From: Joshua Hill
To: Danny Mapili - WPD-C
Cc: Terry Lamb Sr.; Todd Williams; Edwin Lopacki - WPIB
Subject: RE: FERC Swing: Status of Design Review
Date: Tuesday, July 19, 2016 3:36:34 PM
Attachments: image001.png

Good morning Josh,
I would like to check the status of the Design Review for the 100%CD's FERC Swing.

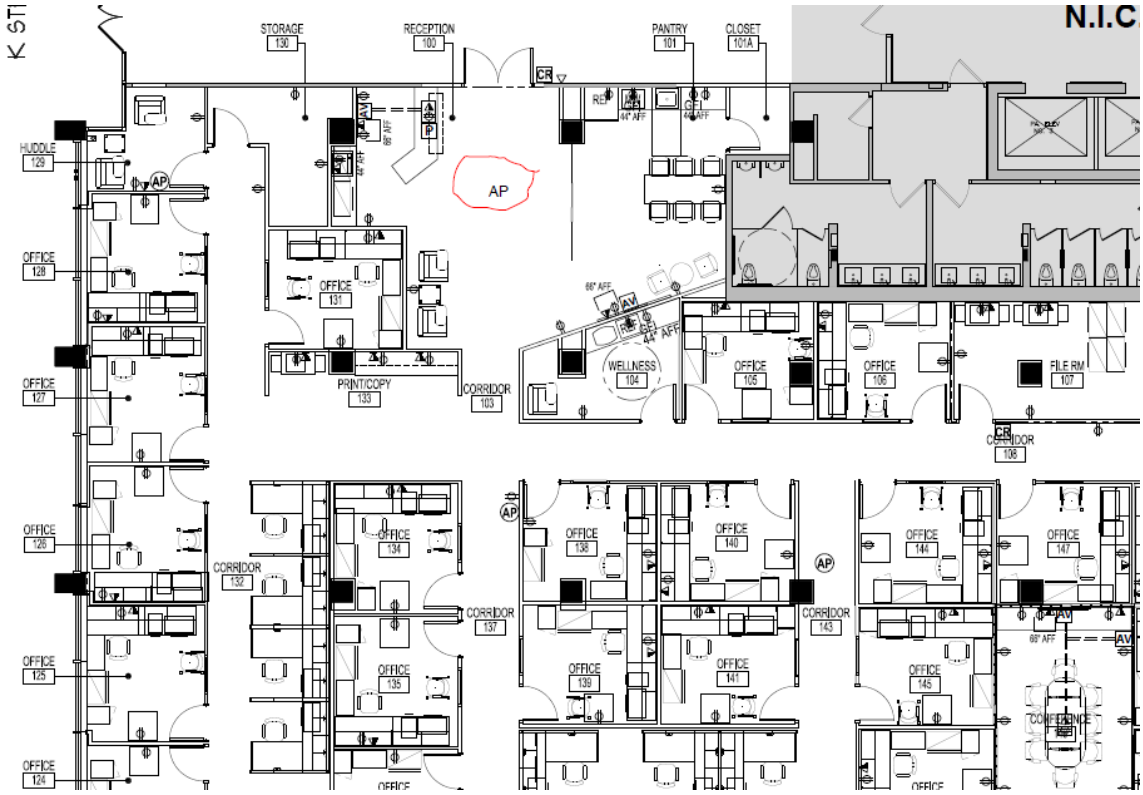
> Danny,
>
> I didn't see FERC's comments (below for reference) addressed in the response…
>
> > On A301, we may need an additional wireless access point located in the vicinity of the entrance to the suite (see drawing below).
> >
> > Also, I do not see where the low-voltage cabling is included anywhere, either in the drawings or specifications. We had discussed this being included in the construction work.

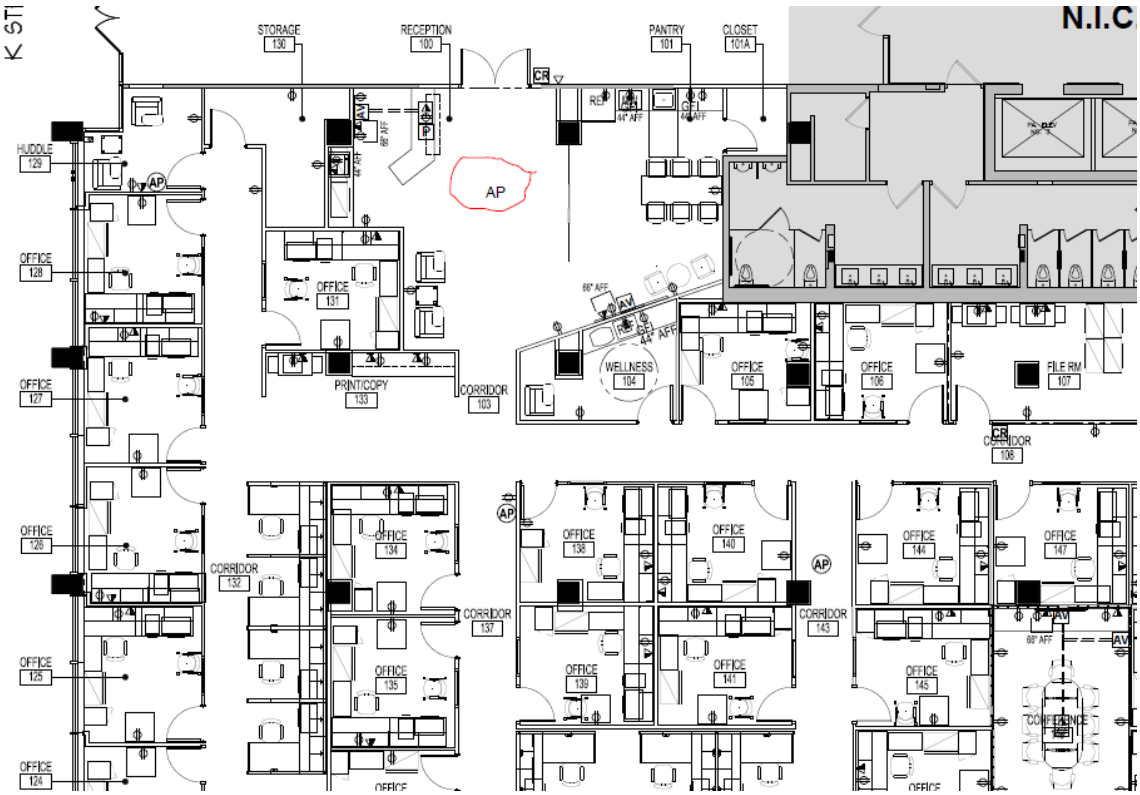
> Danny,
>
> Below are our comments:
>
> On A301, we may need an additional wireless access point located in the vicinity of the entrance to the suite (see drawing below).
>
> Also, I do not see where the low-voltage cabling is included anywhere, either in the drawings or specifications. We had discussed this being included in the construction work.
